Phoenix Ironworks

Design Changes Justification  
Document

PIW-PRP-ZZ-ZZ-TR-A-100003

PRP Architects have been appointed by EWC and Manchester Life Development Company to submit a Non-Material Amendment Application (section 96a) to formally approve the changes to the original planning application prepared by CallisonRTKL (now Arcadis).

Consented design - Bricks and Mortar Colours

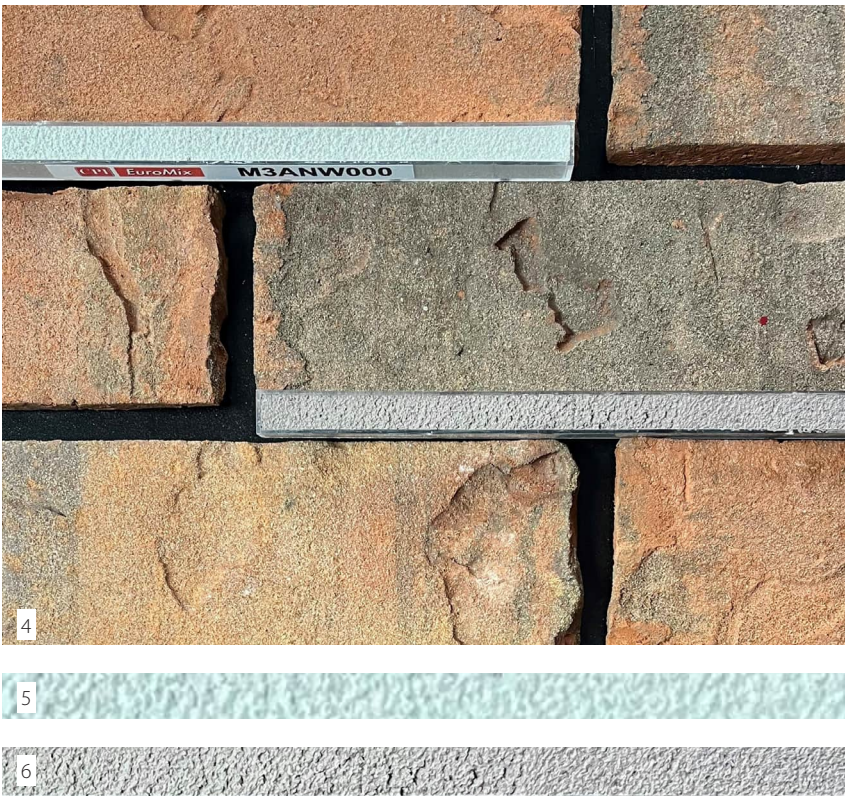
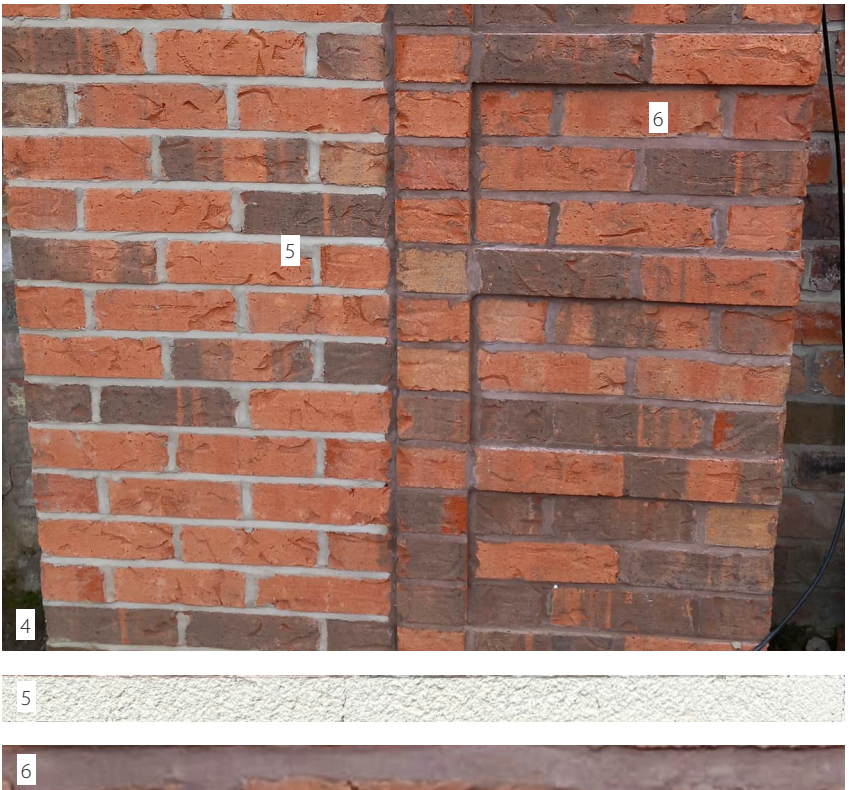
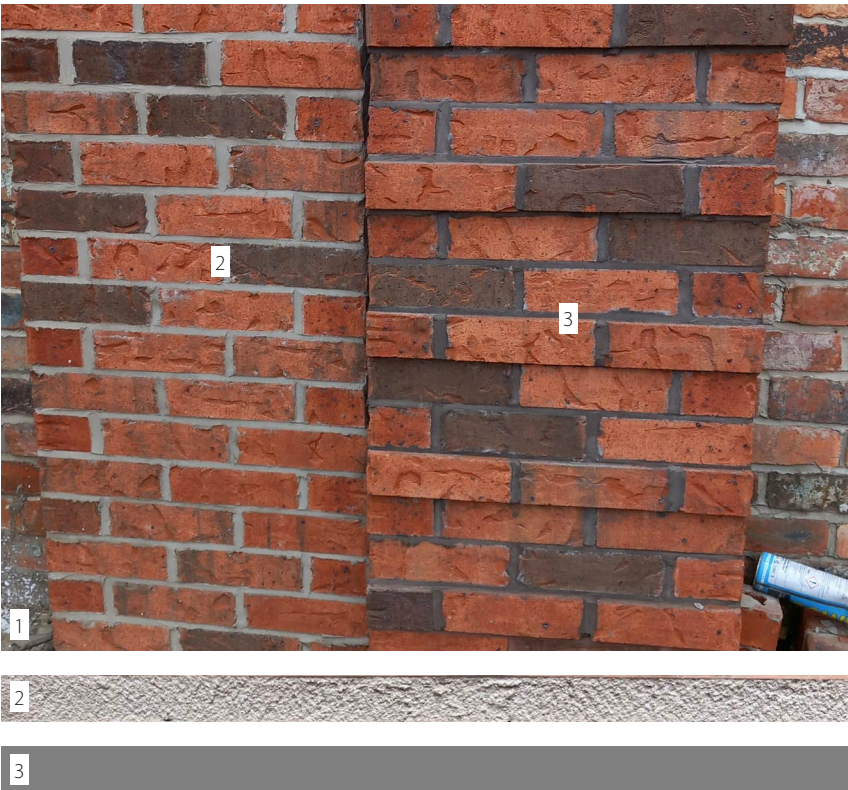
Due to spatial constraints on site, there is insufficient room to accommodate a mortar silo. Additionally, the approved mortar specification is not available in a bagged format. As a result, alternative mortar mixes have been carefully selected to closely match the originally specified product.

To ensure quality and consistency in appearance, two small sample panels were constructed for review and comparison. The selected alternatives were chosen based on their visual compatibility and performance, ensuring they meet the required standards while accommodating site limitations.

Proposed design - The mortar colours as reflected on the small brick panels illustrated above have been agreed with Jennifer Atkinson from Manchester City Council.

Jersey Street Elevation: Consented

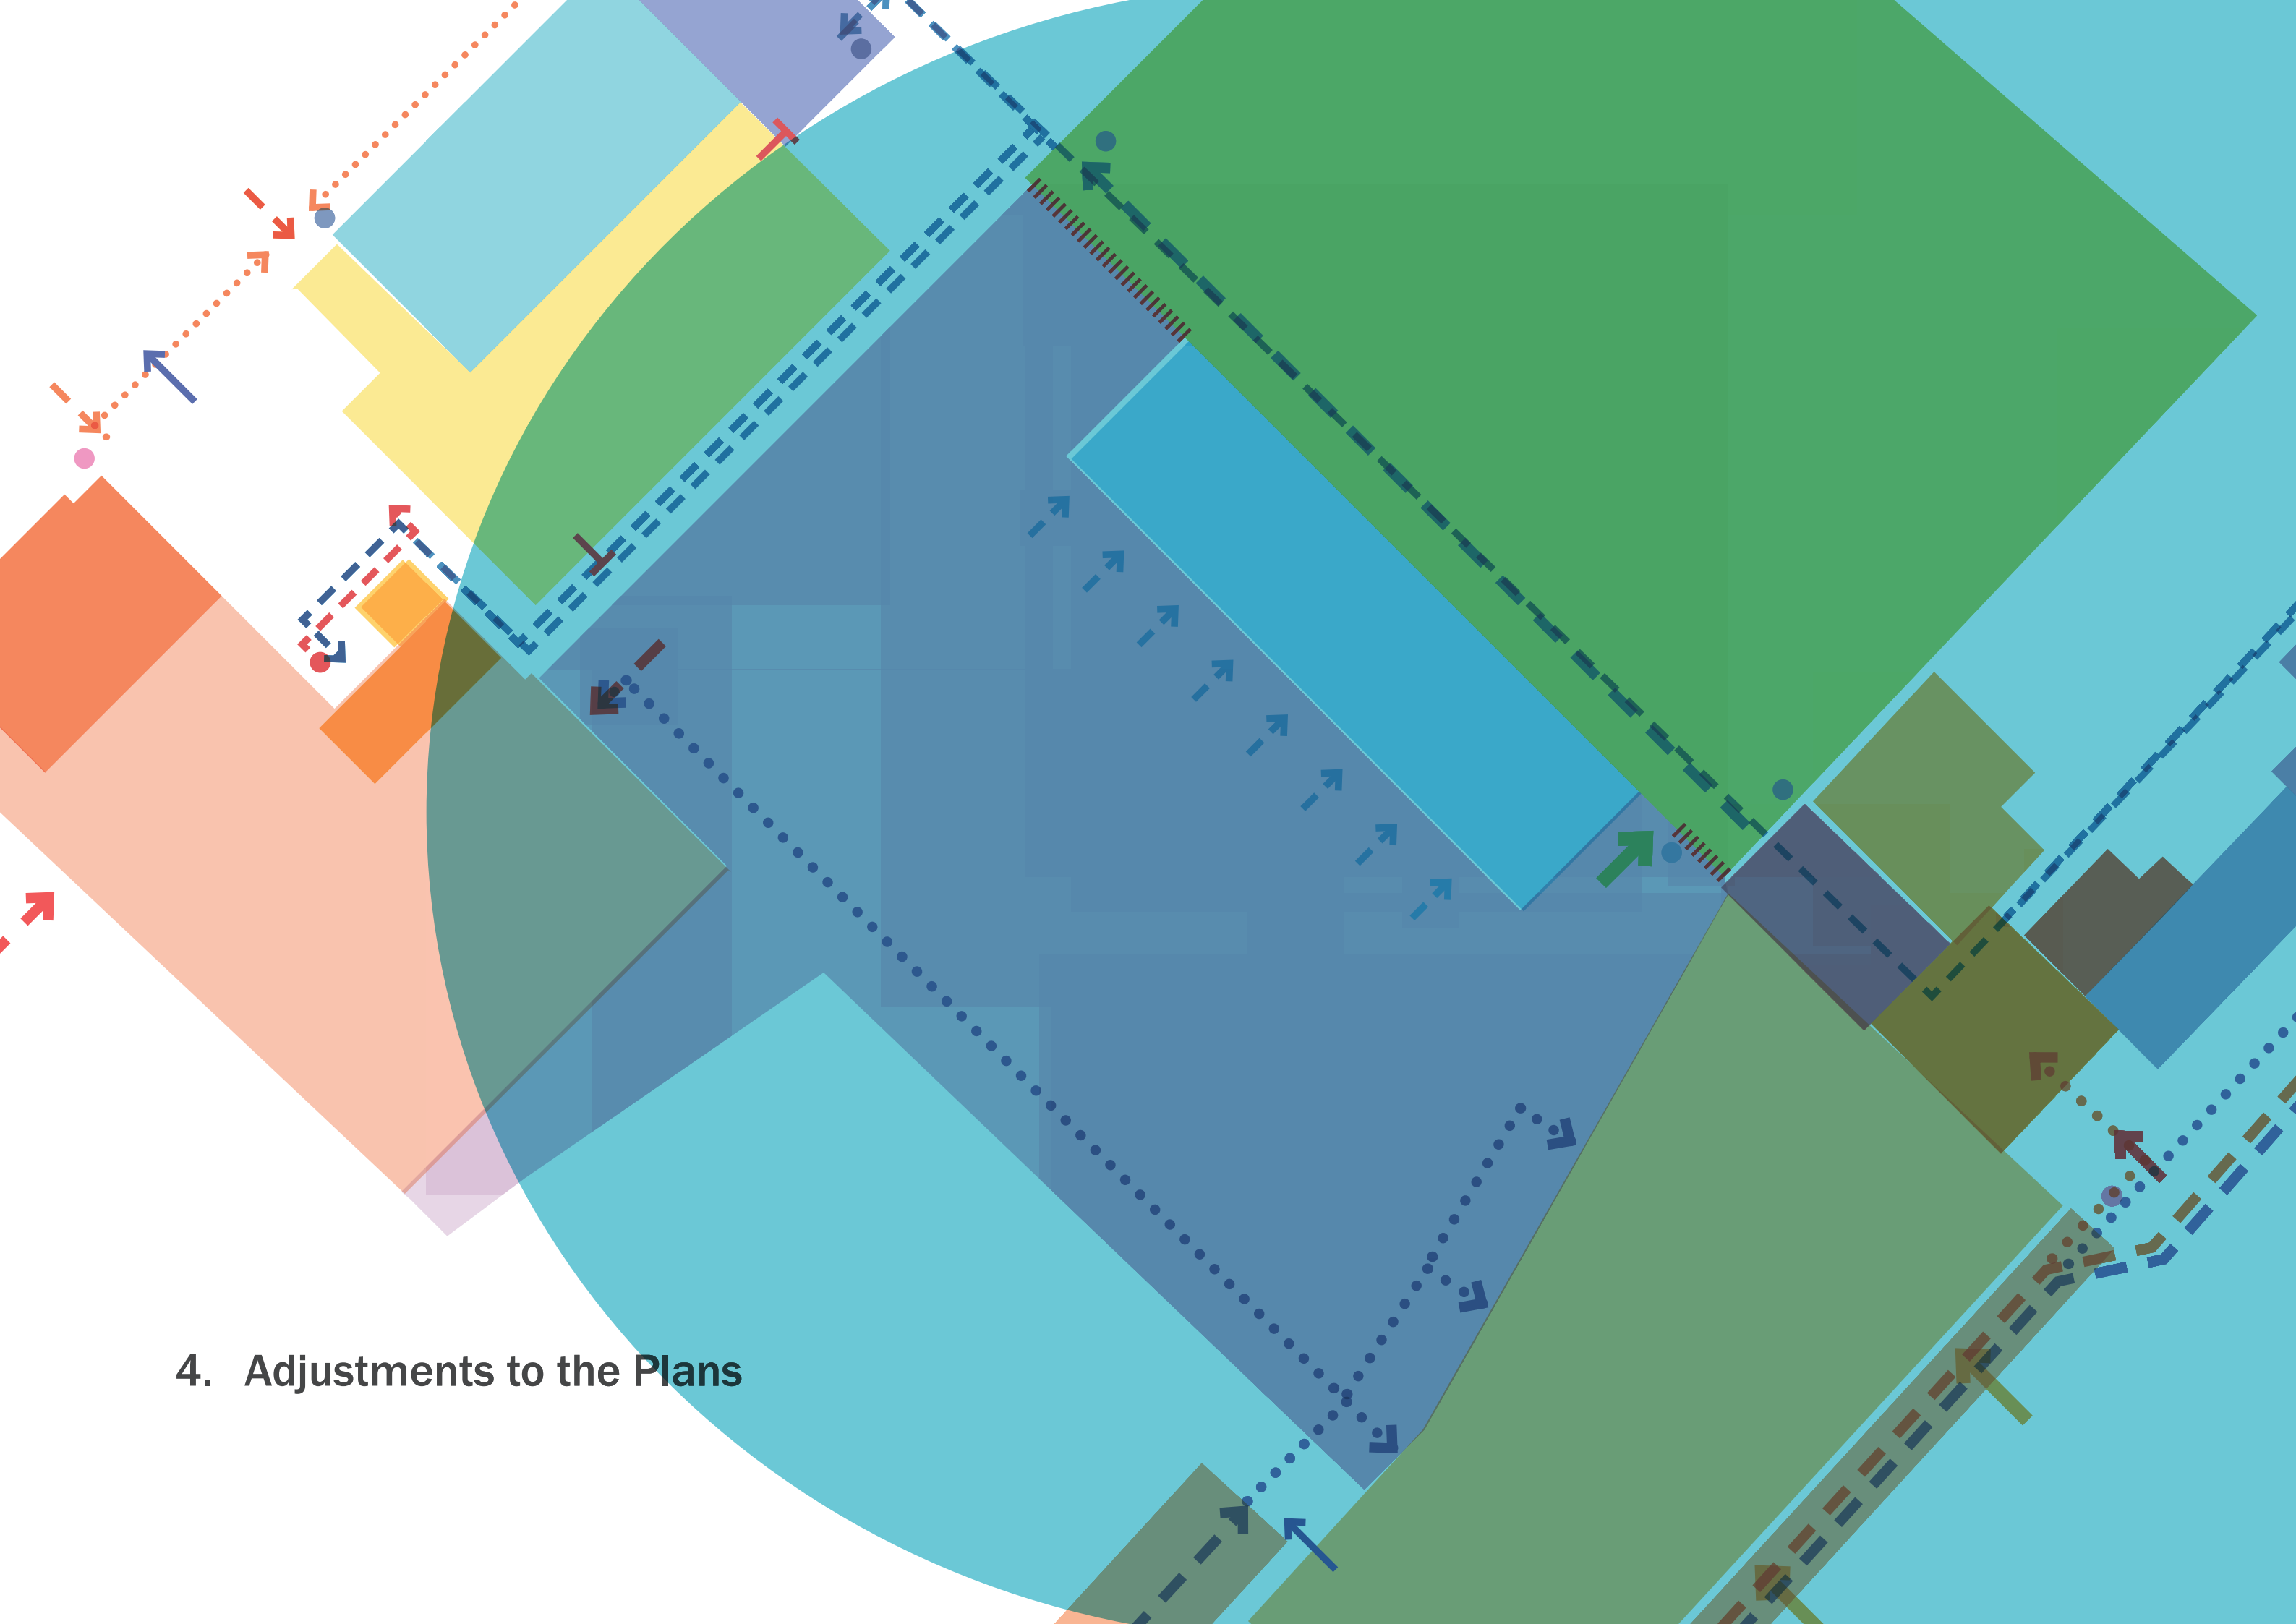
Due to structural limitations the Flemish bond hit and miss pattern has been amended to a stretcher bond hit and miss pattern to allow for cross bed reinforcement in alternative courses.

4.1. Ground Floor Layout changes - Plant

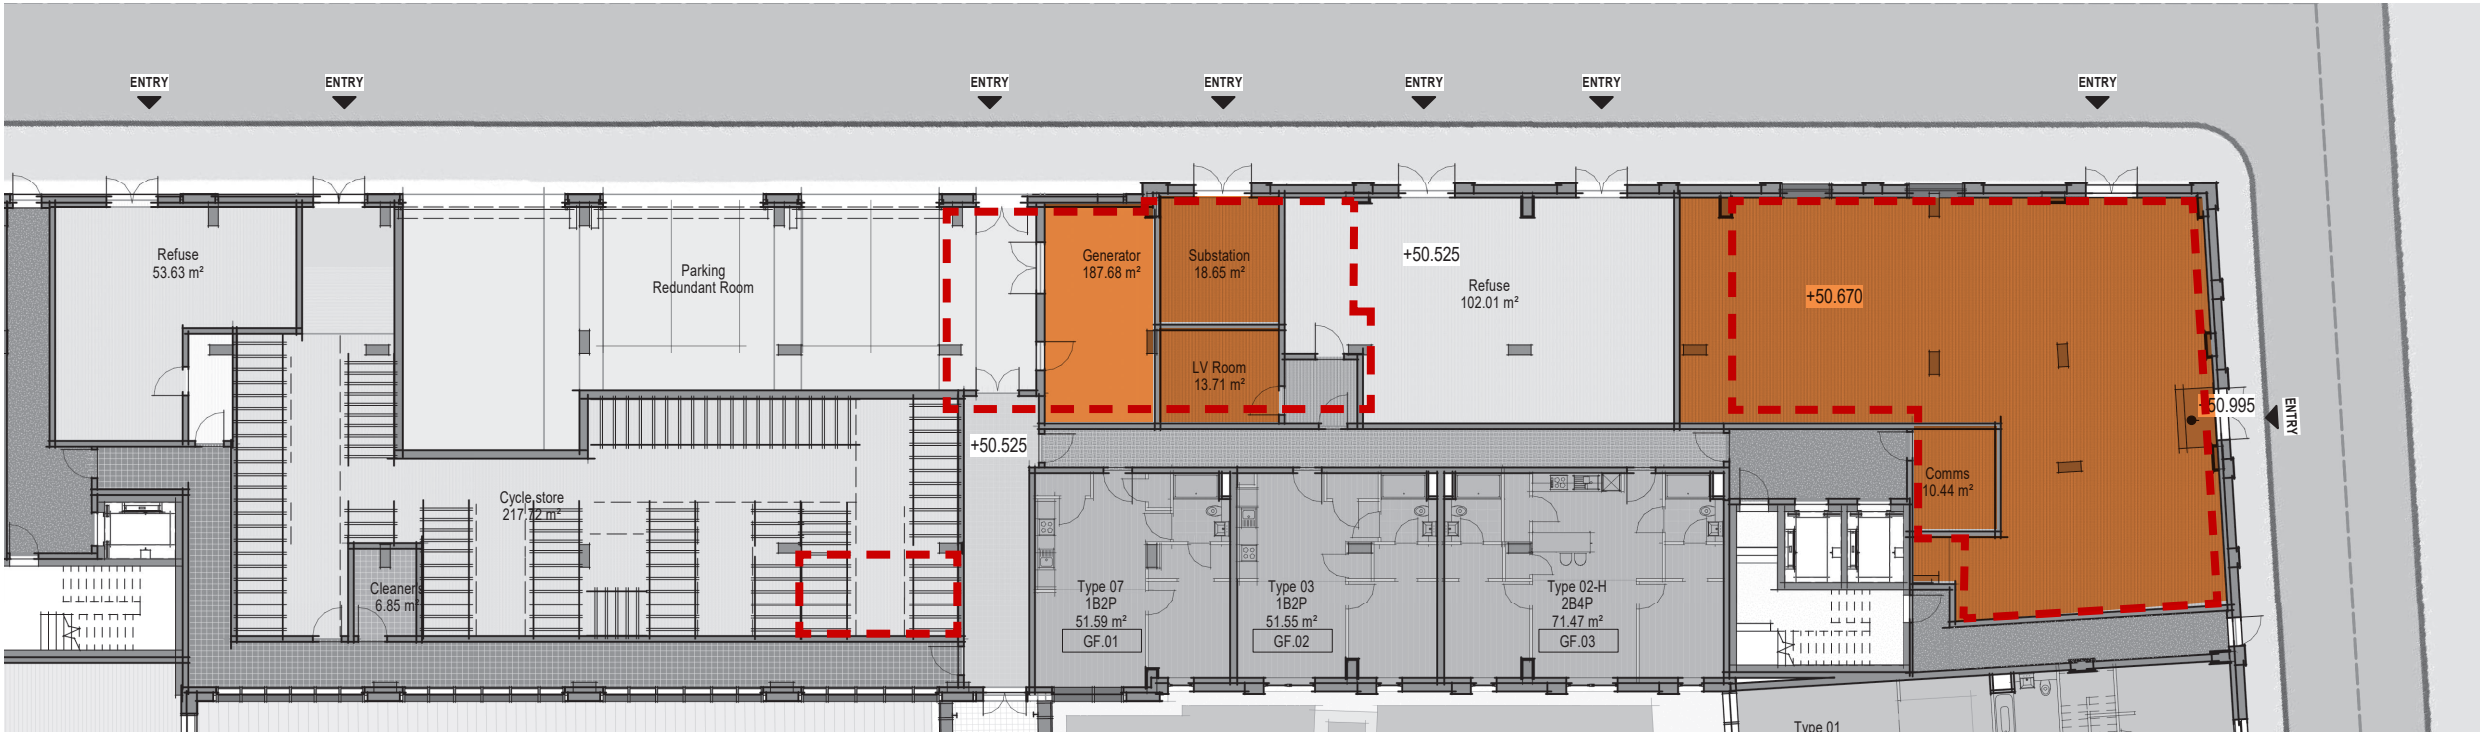
Due to MEP design development from Stage 3, the orientation of the Generator Room needed to rotate 90 degrees to accommodate two large louvres on the external façade.

This change necessitated a reconfiguration of the back-of-house areas along the Naval Street façade. Specifically, the substation, LV switch room, and refuse store were shifted to the right, and the comms store was relocated to the cycle store.

Core 1

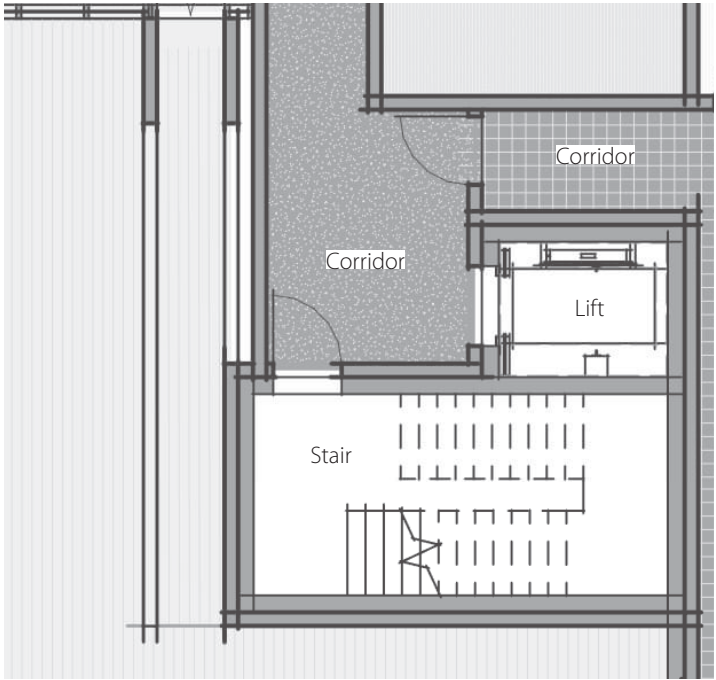
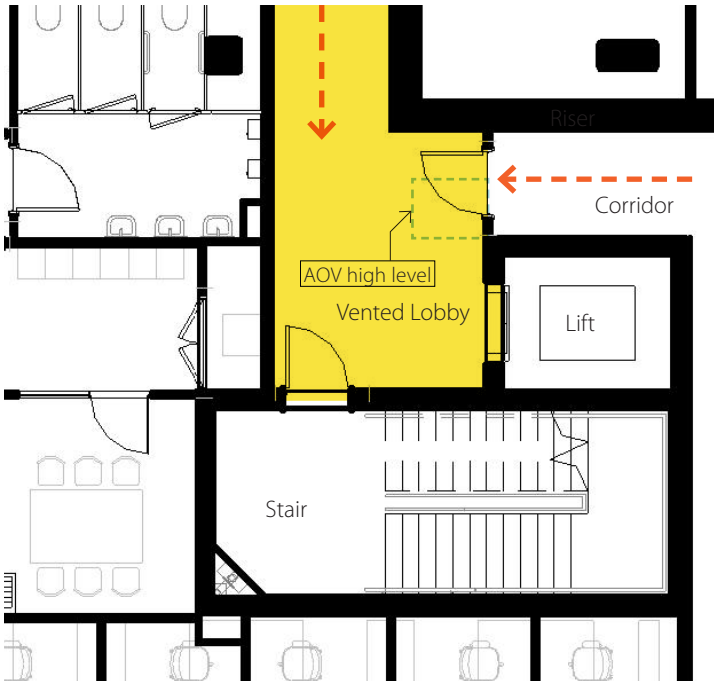
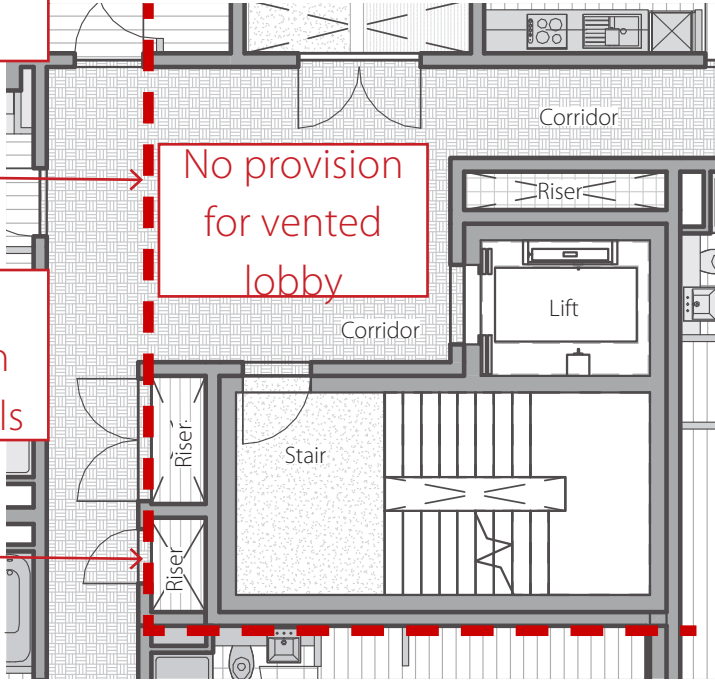
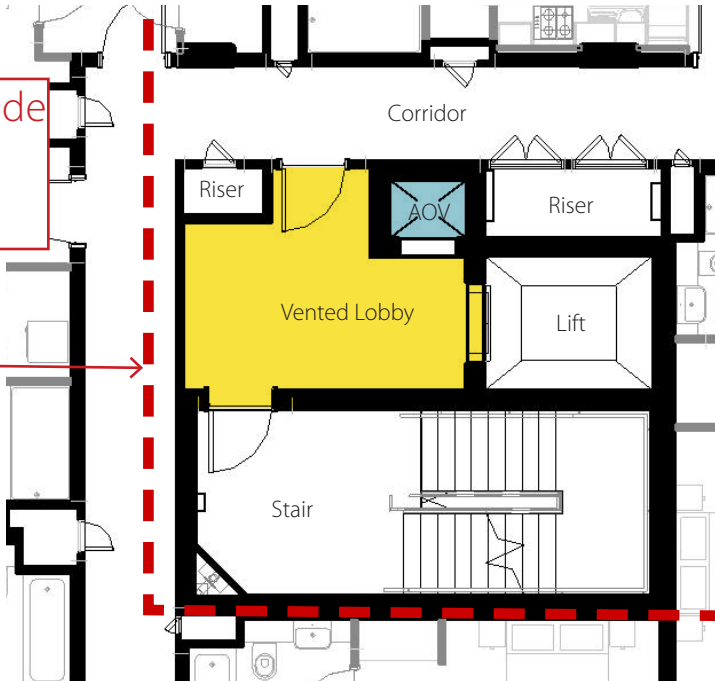
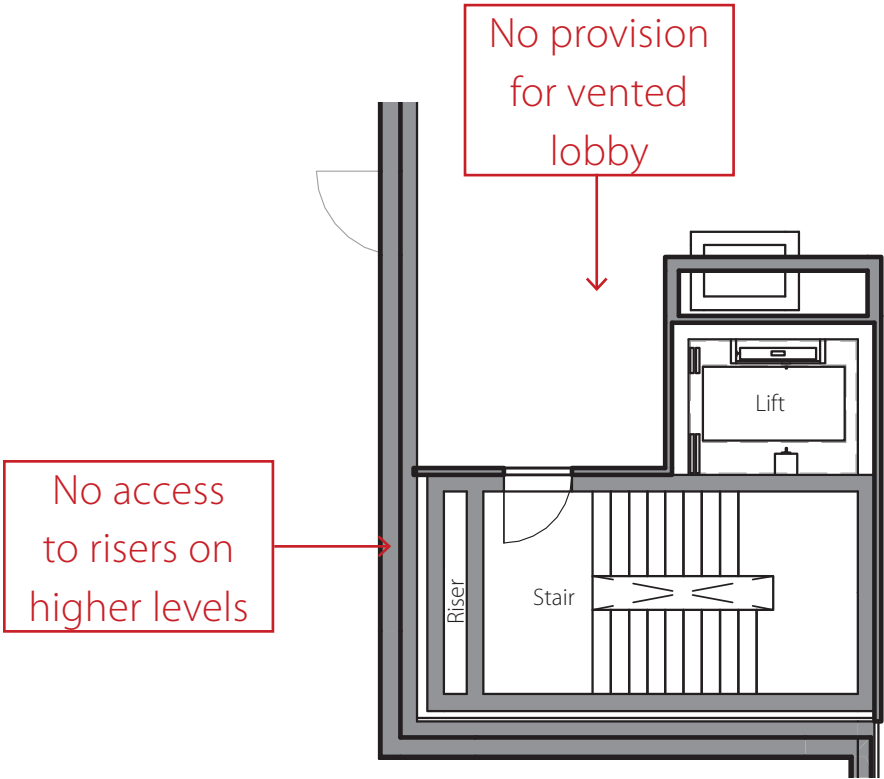
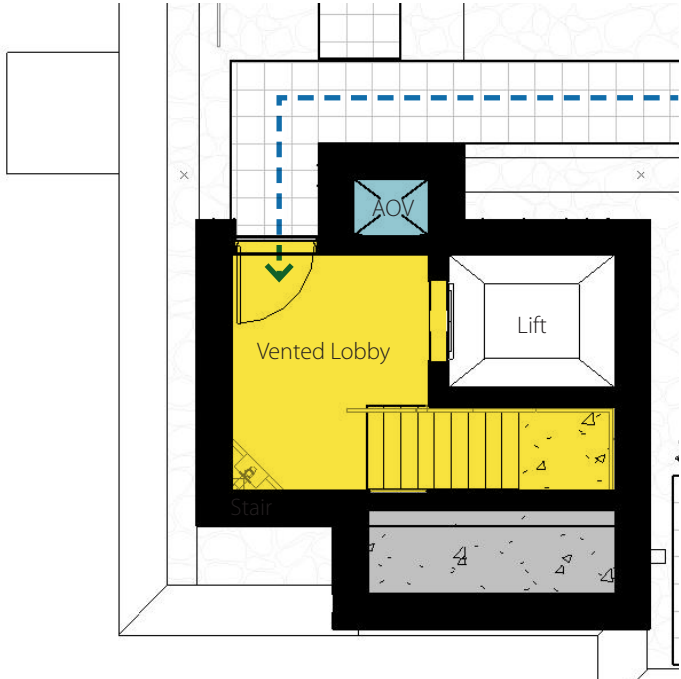
The primary change impacting the original core design as a result of the BS 9991:2024 update was the requirement to provide natural ventilation to the fire-fighting and evacuation lift lobbies.

While reconfiguring the core layout to accommodate this new requirement, we also took the opportunity to relocate the riser to the opposite side of the corridor, enabling direct access on the top floor.
